## Product Change Notice (PCN)

PCN Number: PCN-0451086R-01

Product(s) Affected: PJ-038-SMT and PJ-039-SMT

### PJ-038-SMT

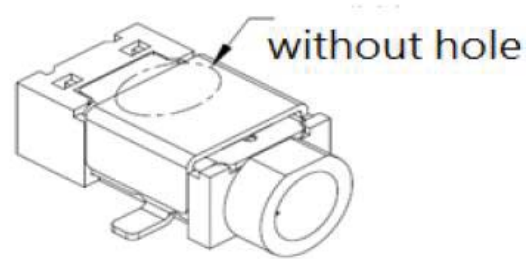
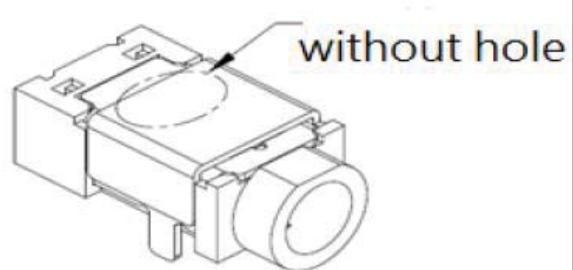
Reason(s) for Change: replacing existing mold maintain efficient production and quality.

Description of Change: appearance change as shown below:
